E4982A-02

S E R V I C E N O T E

E4982A – LCR Meter, 1MHz to 3GHz

E4982A LCD Touch Panel Display Assembly Replacement Part Change

Figure 1-1

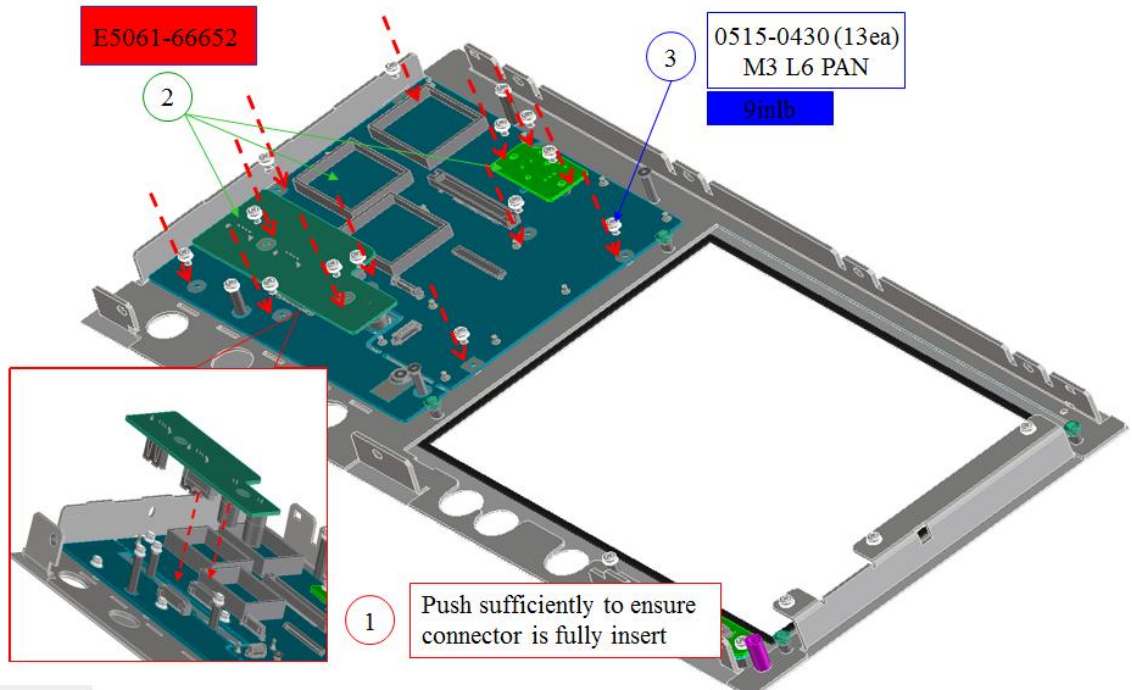
1. Reuse and install the keyboard, keyboard PCA and power switch PCA on the new front panel sub as shown in figure 1-1.

Note: The front panel, panel sub and cover shield are required to be replaced due to dimension changes. Front panel frequency label has to be purchased separately according to unit frequency options.

Figure 1-2

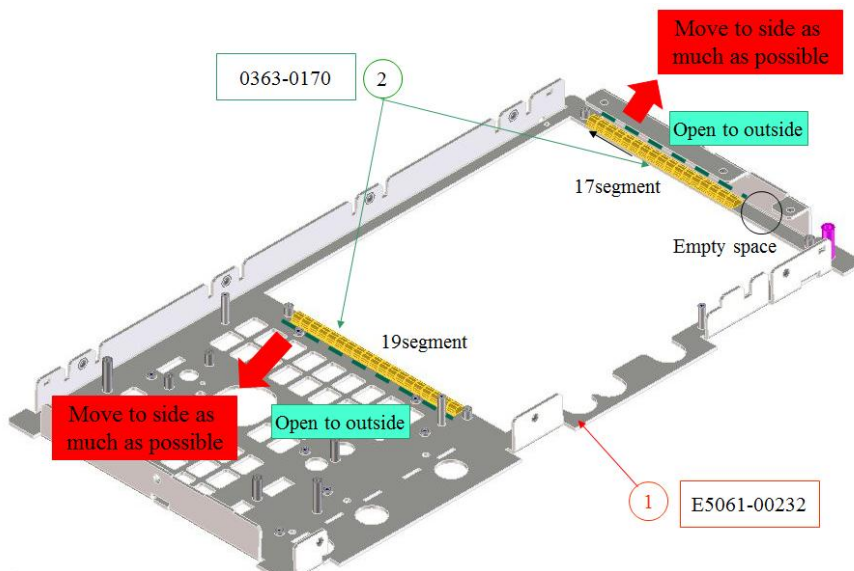
2. Install the gaskets as shown in Figure 1-2. Figure 1-3 illustrates the Front panel with the keyboard installed.

Figure 1-4

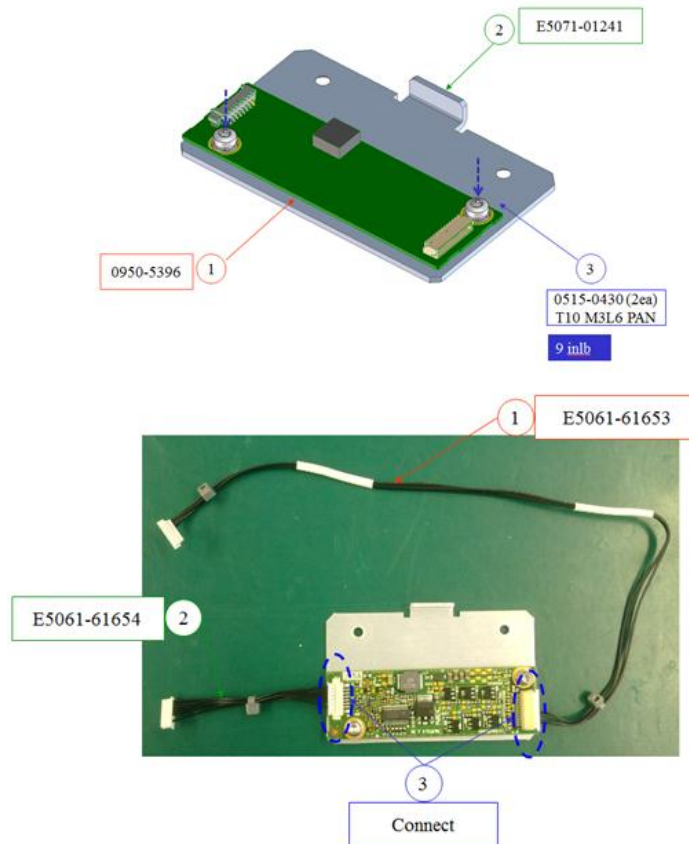
3. Install the inverter on the bracket before connect the cable assembly to both ends as shown in figure 1-4

Figure 1-5

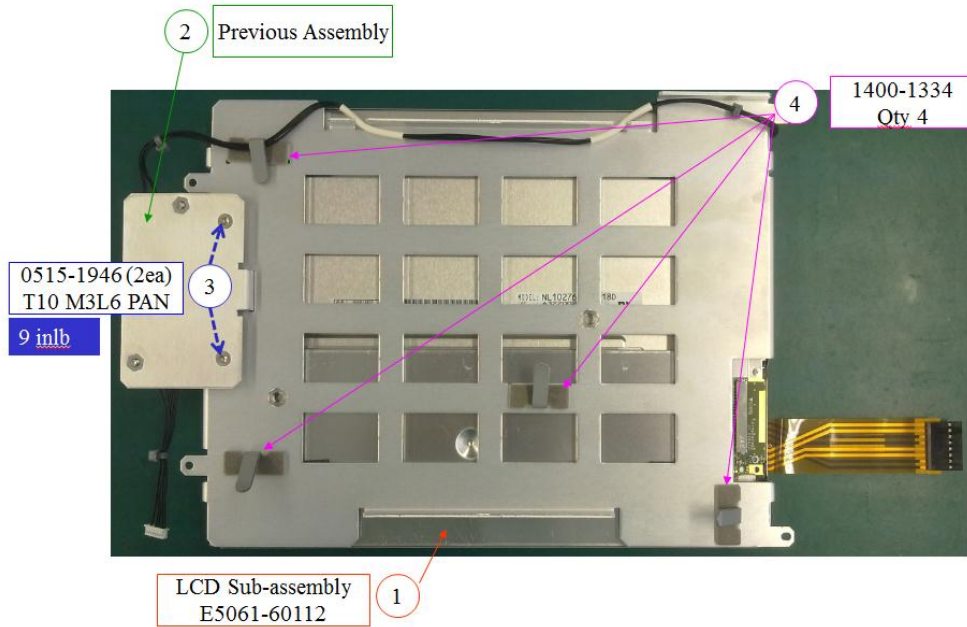
4. Install the inverter assembly onto the new LCD T/P display assembly (with LED backlight). Refer to figure 1-5 for details.

Figure 1-6

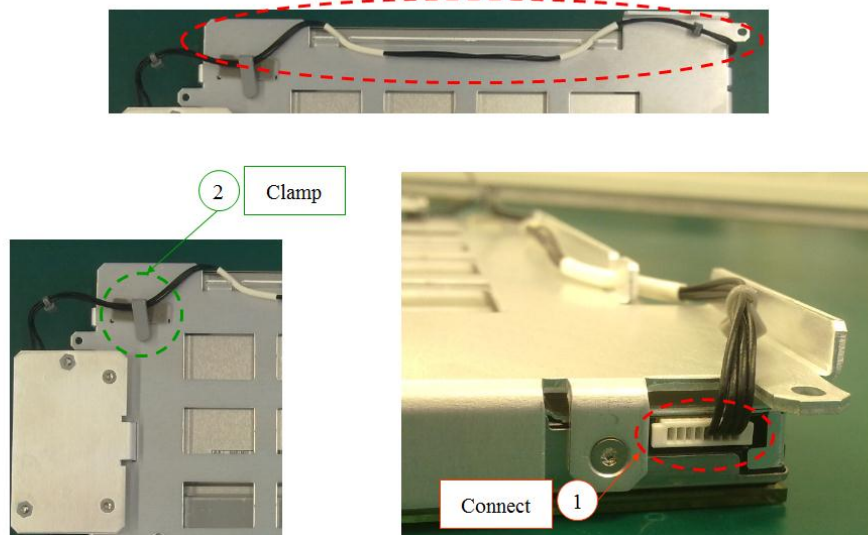
5. Connect and route the LCD display assembly cables accordingly.

Note: Wire routing condition

Figure 1-7

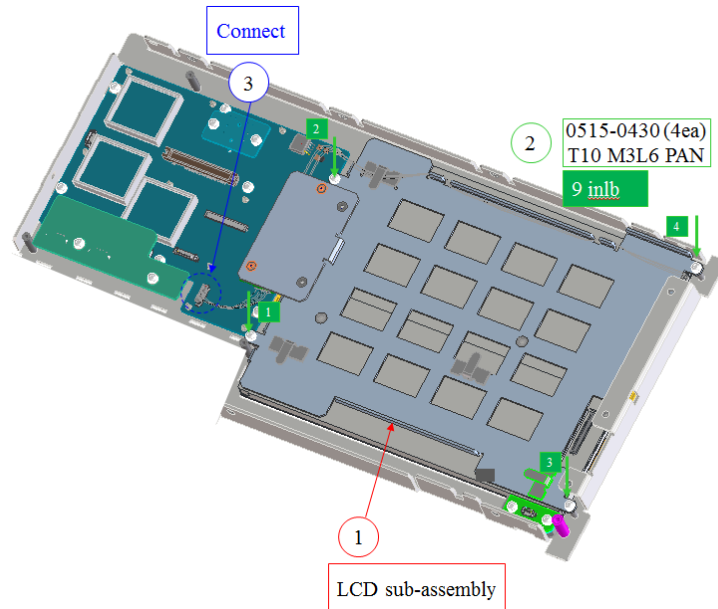
6. Install the LCD T/P Display Assembly onto the LCD Front Panel. Fasten the screws according to the following sequence. Connect all cable assemblies as shown in figure 1-7.

Figure 1-8

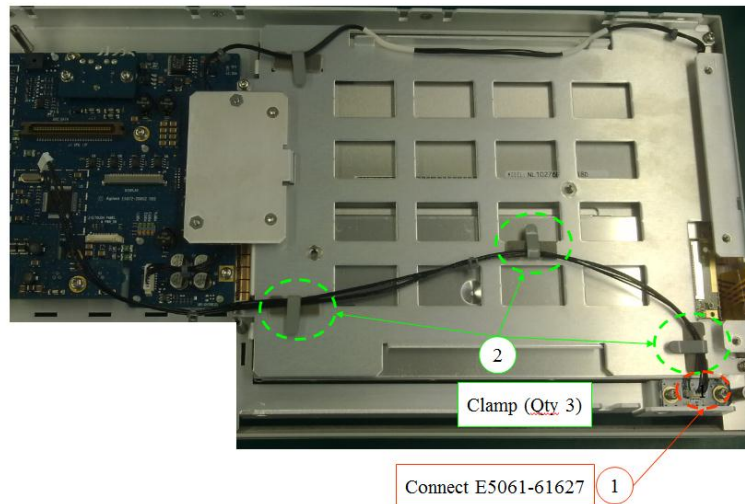
7. Connect, route and clamp the power switch cable assembly as shown in figure 1-8

Figure 1-9

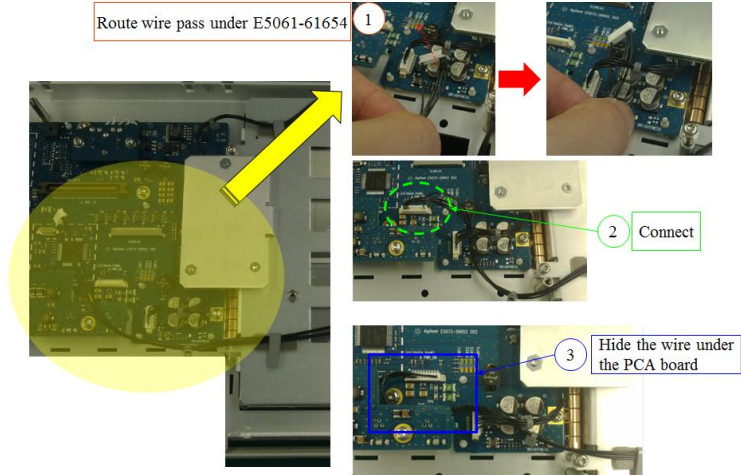
8. Connect the cable assemblies to the keyboard PCA as shown in figure 1-9.

Figure 1-10

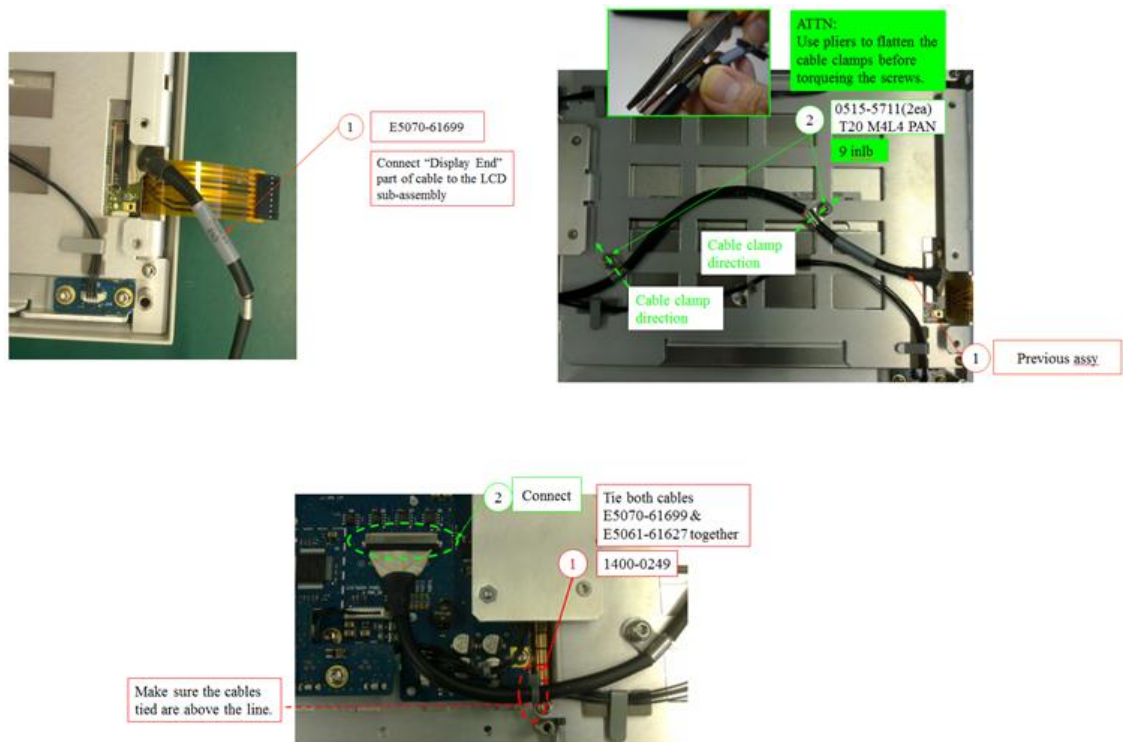
9. Connect the LCD T/P display cable assembly as shown. Fasten the screws in securing the cable. Tie the LCD T/P Display cable assembly to the Power switch cable assembly as shown in figure 1-10.

Figure 1-11

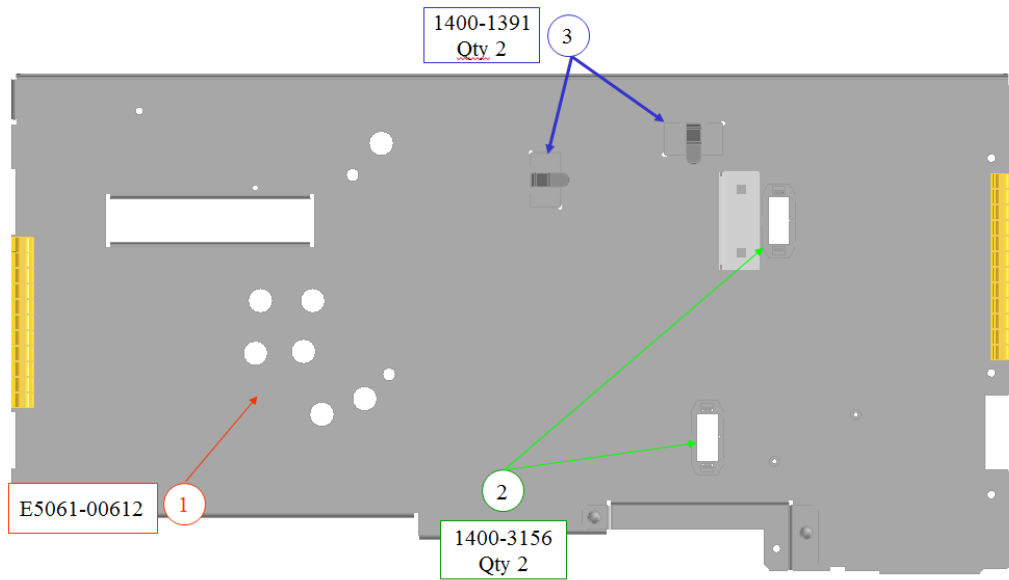
10. On the Front Panel back cover shield, install the cable clamp as shown in figure 1-11

Figure 1-12

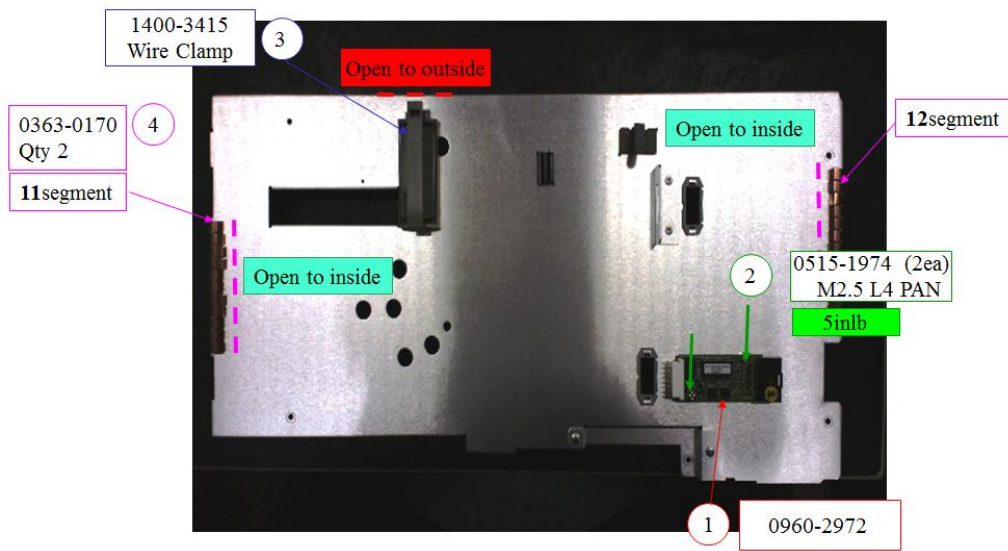
11. Install the cable clamps and Gasket (RFI fins) on the back cover as shown in figure 1-12.

Figure 1-14

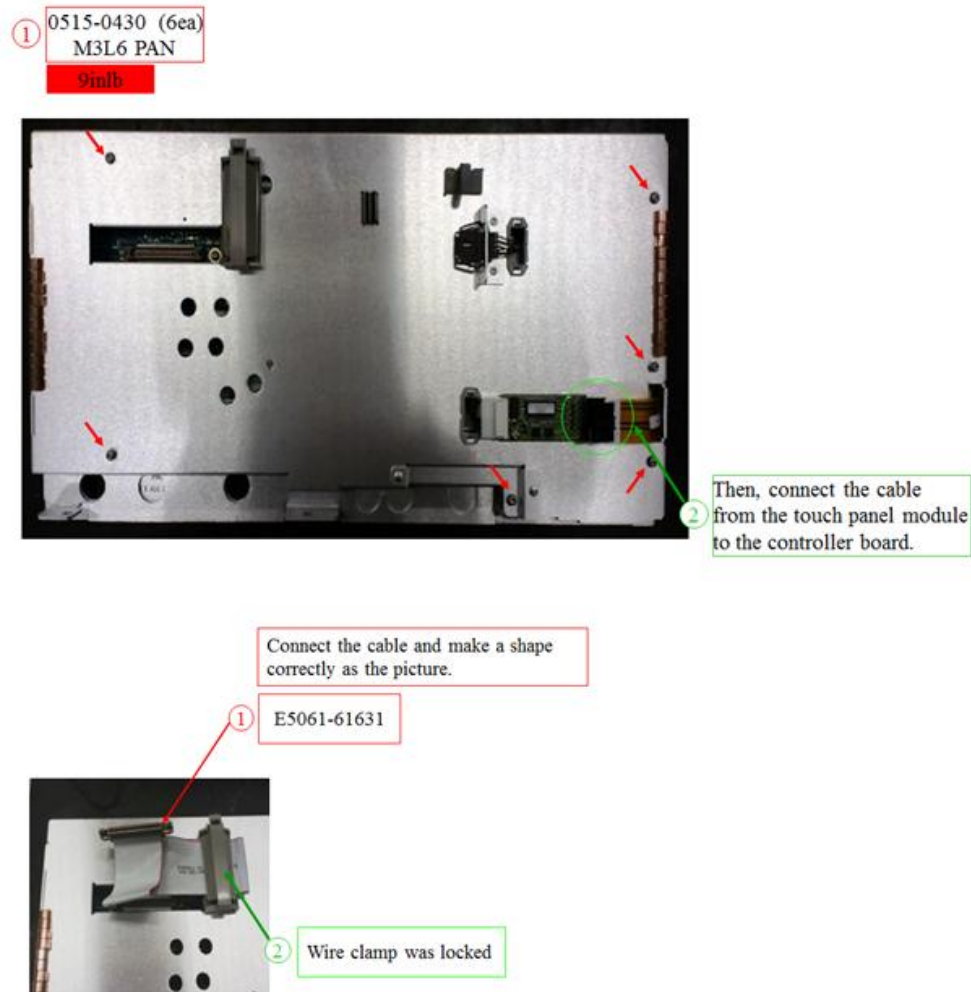
13. Shown would be the completed installation of the assemblies. Kindly ensure the connections of the cable assemblies are good and properly secured. Fasten the six screws in securing the shield (back cover) to the Front Panel Assembly. Refer to figure 1-14 for details.
